SUBSURFACE WASTEWATER DISPOSAL SYSTEM APPLICATION

Subject: Western View Golf and Country Club Condominiums, Bolton Hill Road, Augusta

Subject: Engineered Disposal System approval, Western View Golf and Country Club Condominiums, Bolton Hill Road, Augusta

Subject: Engineered Disposal System, Western View Golf and Country Club Condominiums, Bolton Hill Road, Augusta

DISPOSAL AREA CROSS SECTION

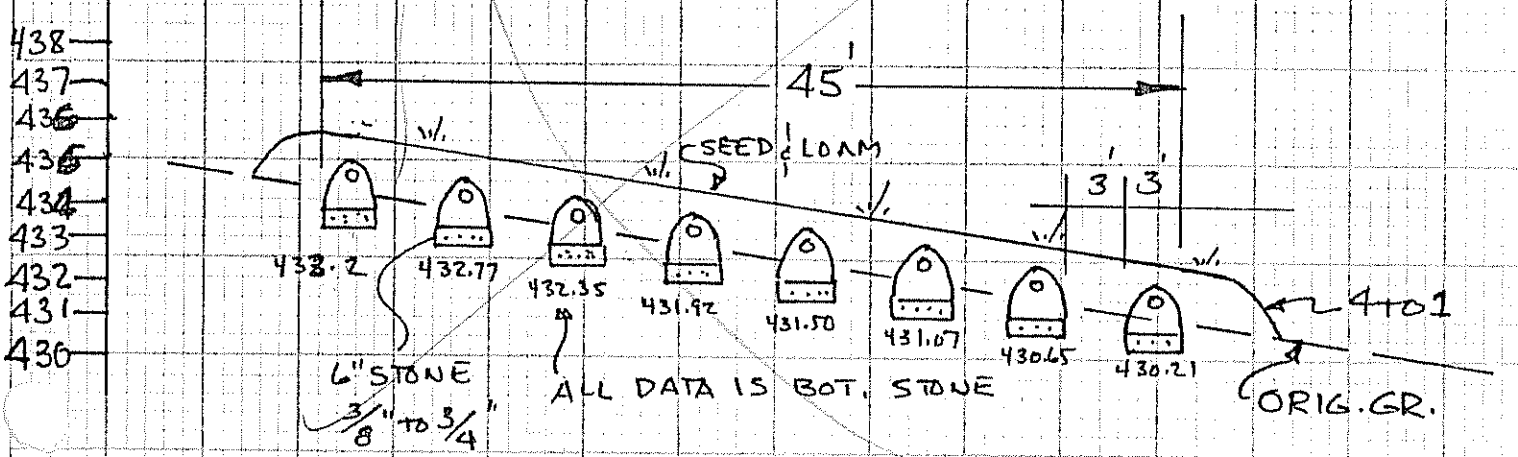
(NOTE: USED LIMITING FACTOR = 24" INSTEAD OF 38")

SUBSURFACE WASTEWATER DISPOSAL PLAN

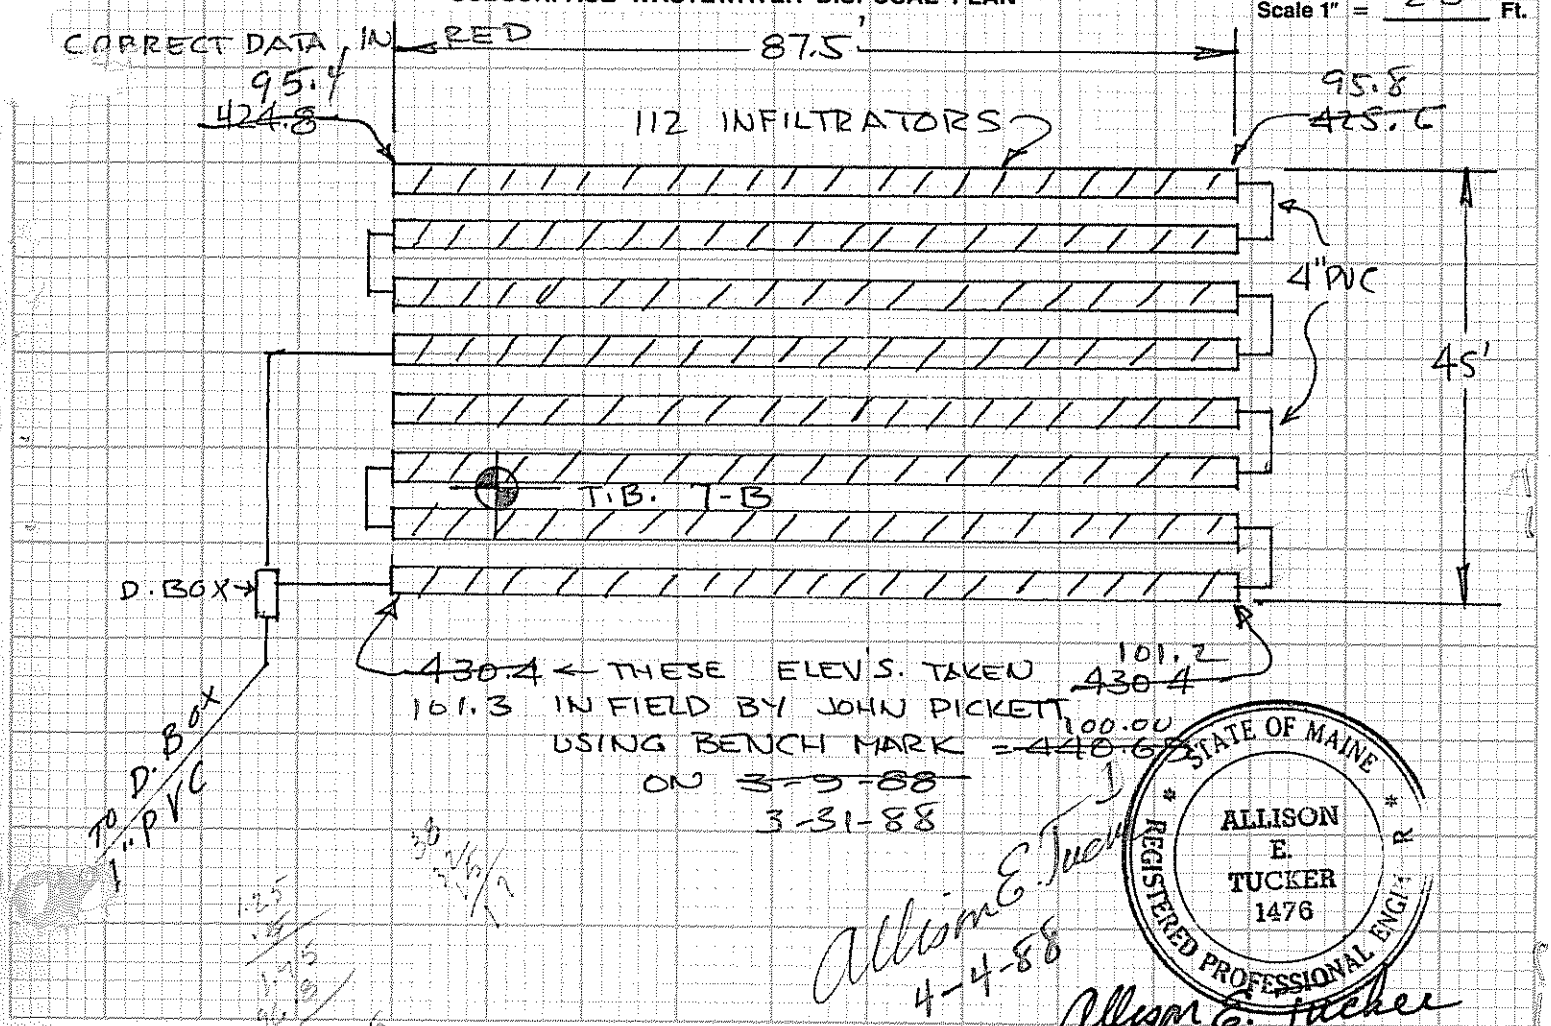
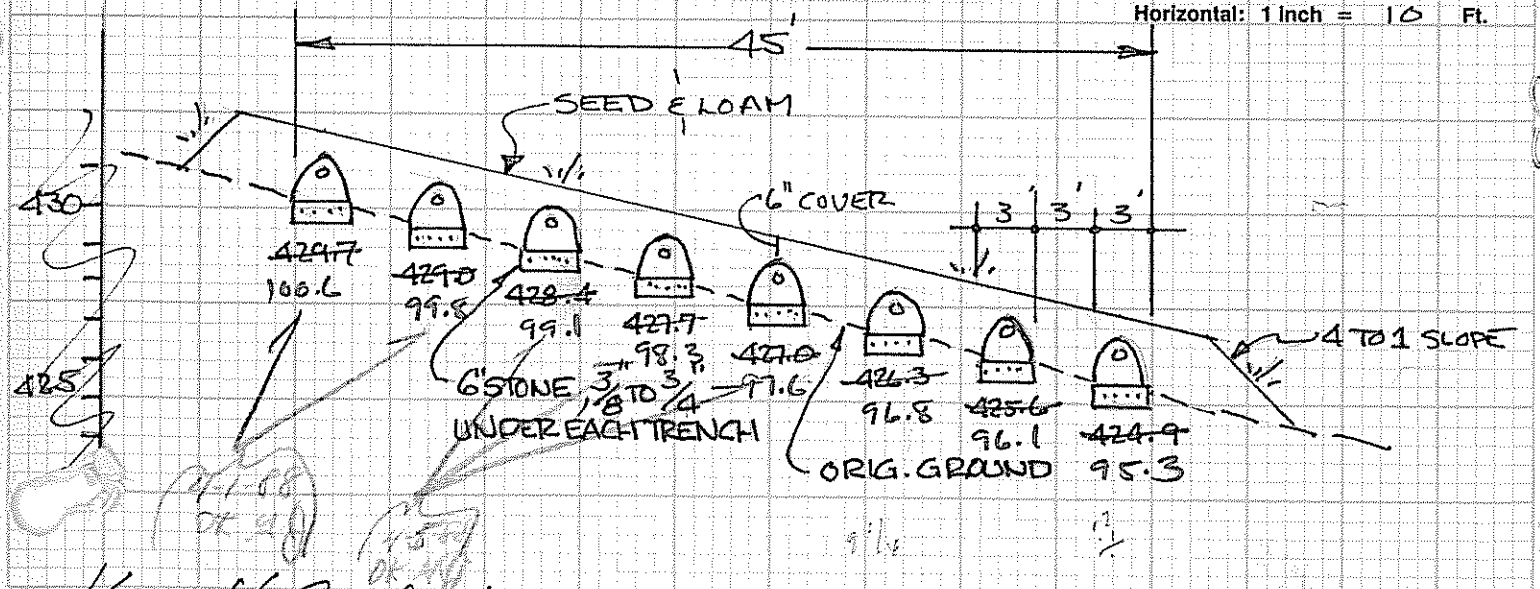
Reference Elevation is 100.00 ~~440.69~~ SEE BELOW
Bottom of Disposal Area
Top of Distribution Lines or Chambers

~~NAIL IN GROUND JUST WEST OF BLDG @ N. END~~ NAIL IN TREE

SUBSURFACE WASTEWATER DISPOSAL PLAN

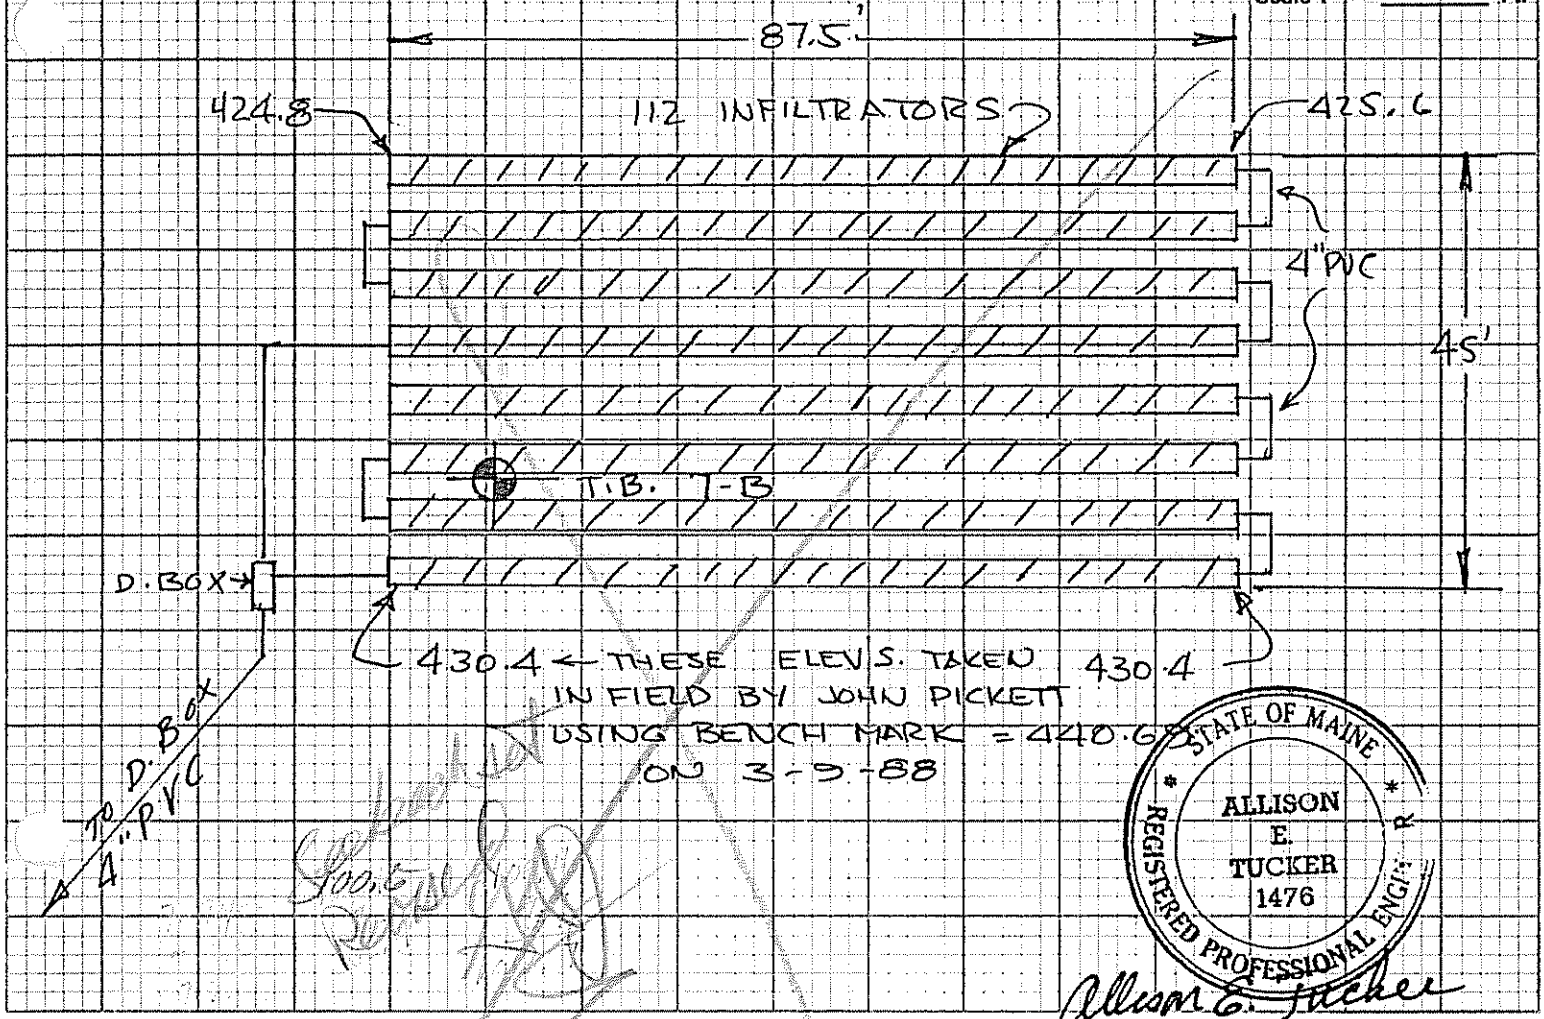
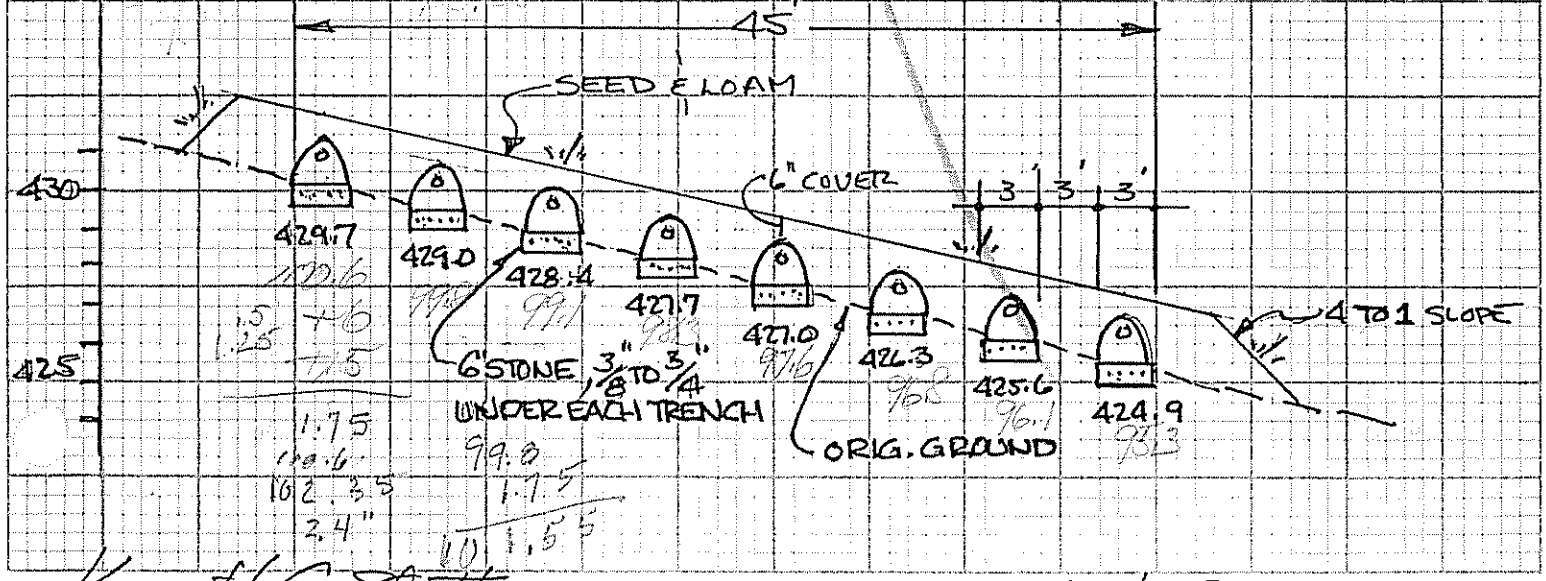
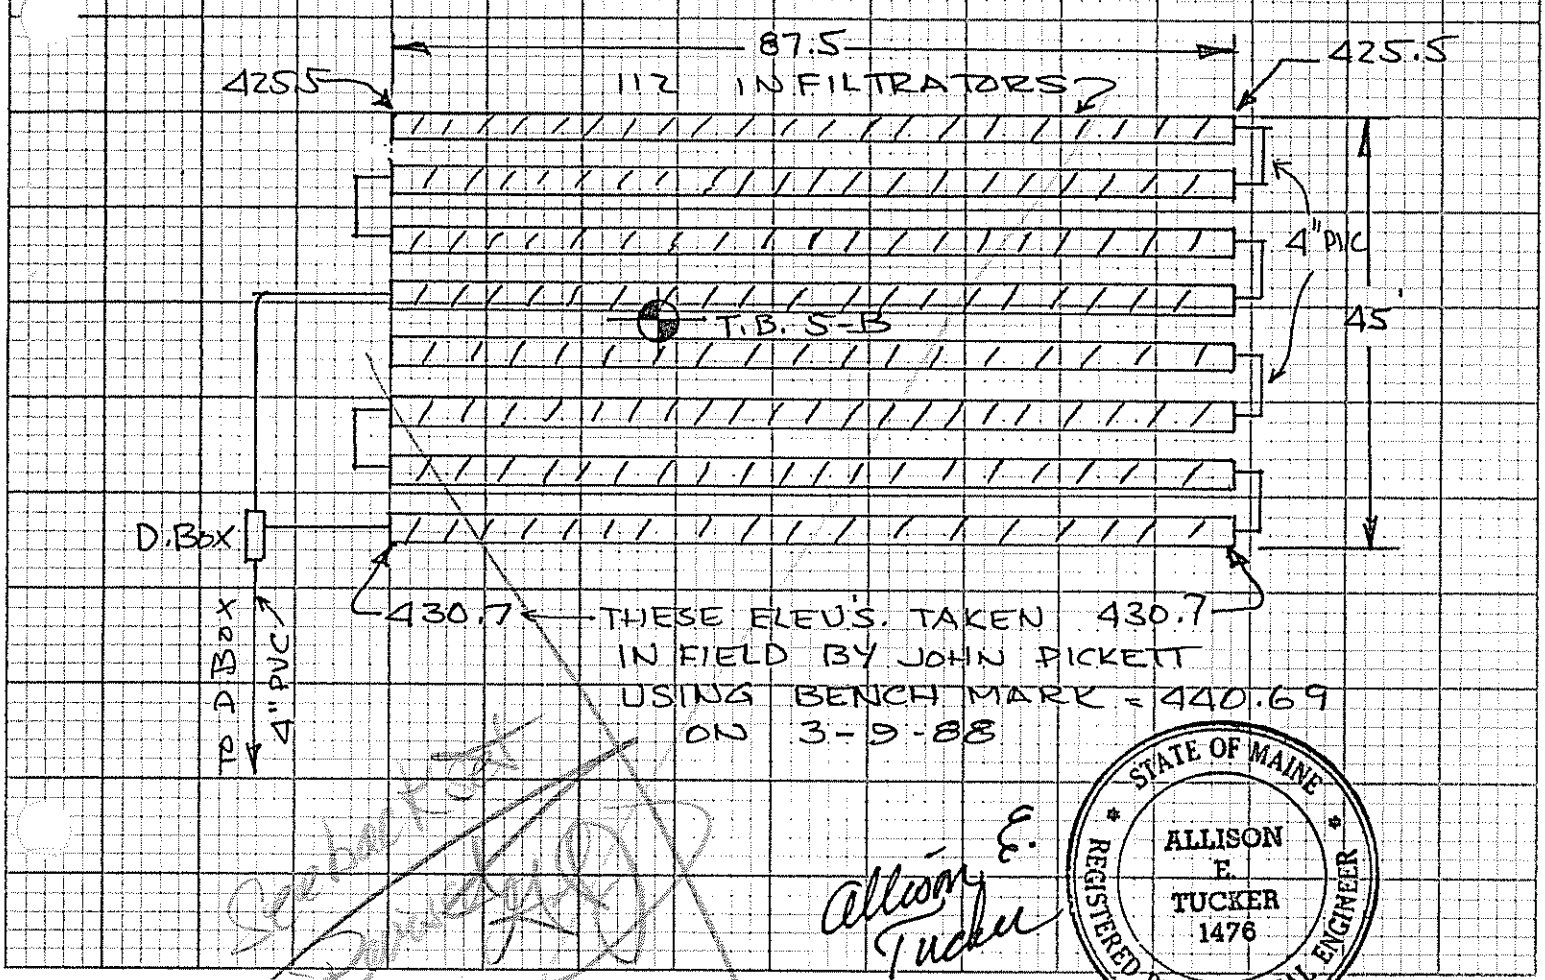
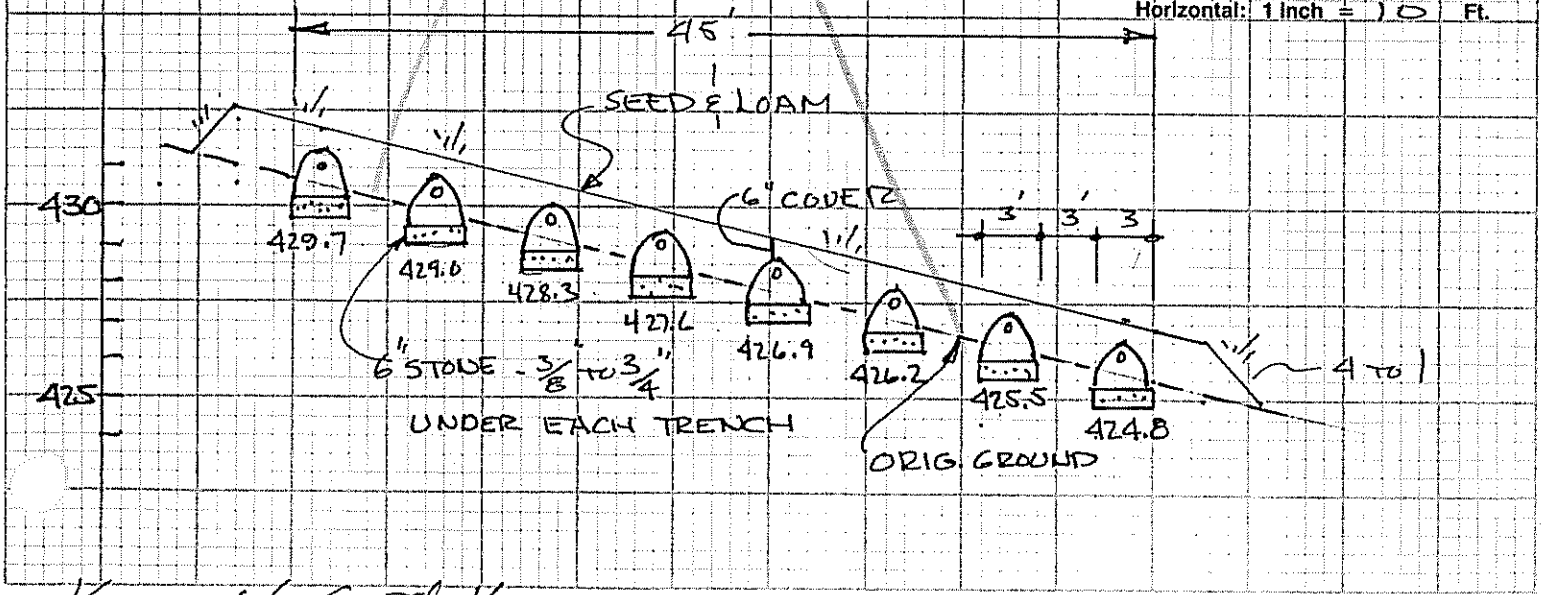
This set to amend permit #868 issued 3-3-88
New Location & New Elevation on reference.

This office is in receipt of revisions to the HHE-200 form and plan for the referenced project; said revisions dated March 8, 1988 by yourself. The revisions were necessitated by discrepancies in ground contours.

The Division hereby approves the revisions. Feel free to contact me with any comments or questions.

SUBSURFACE WASTEWATER DISPOSAL PLAN

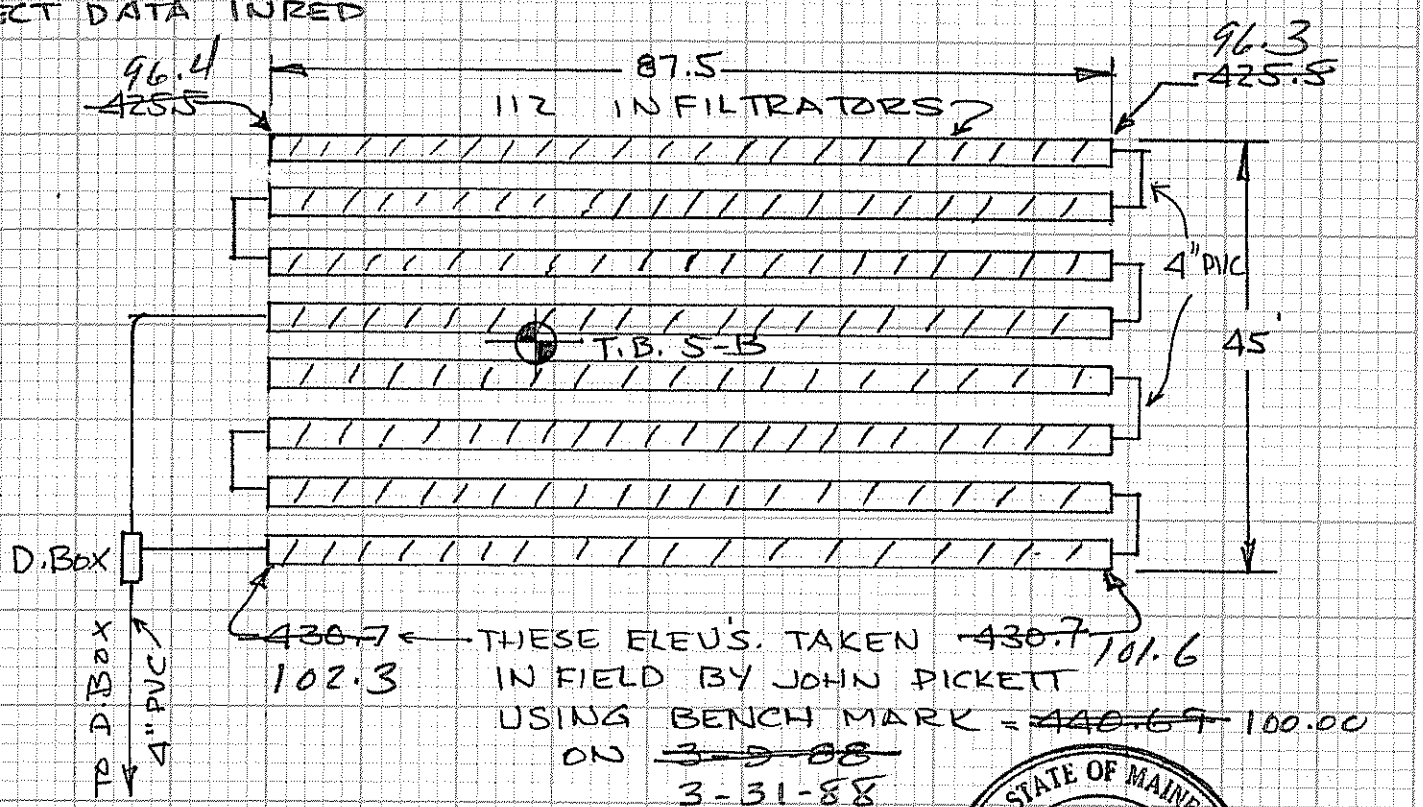
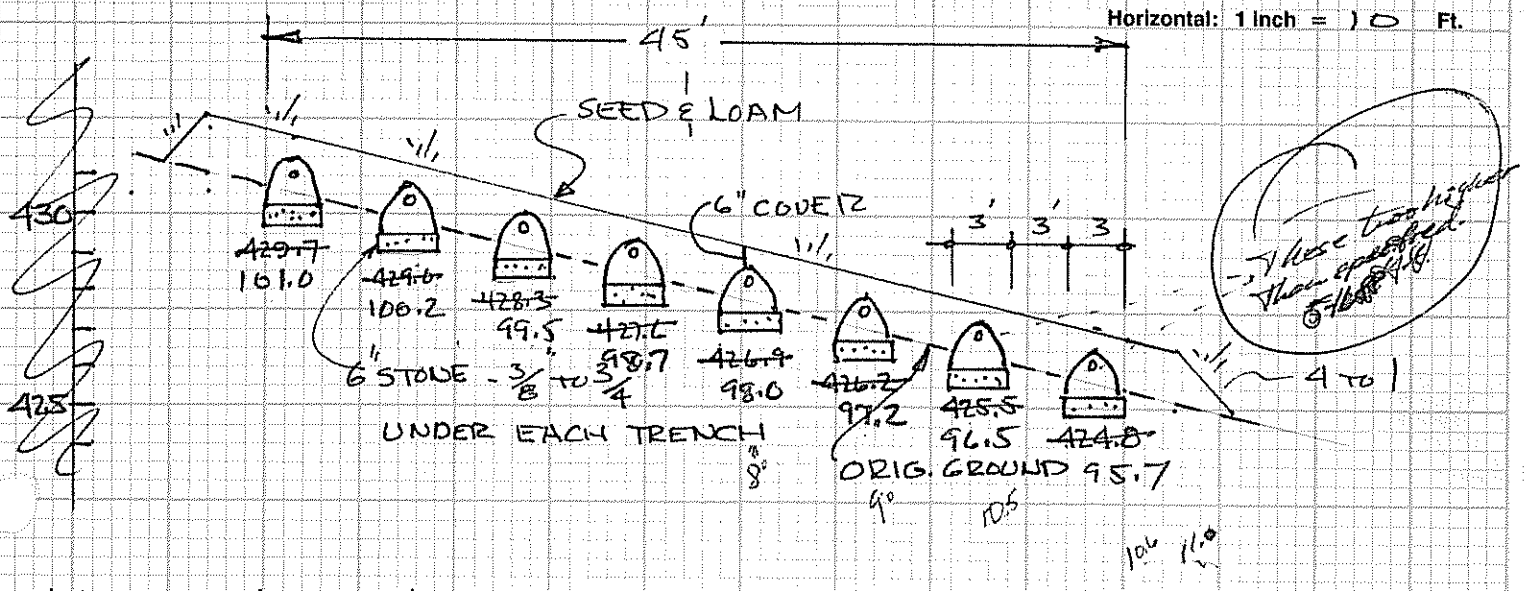
CORRECT DATA INRED

Reference Elevation is 100.00 440.69
Bottom of Disposal Area SEE BELOW
Top of Distribution Lines or Chambers

NAIL IN GROUND JUST WEST OF BLDG N. END
NAIL IN TREE
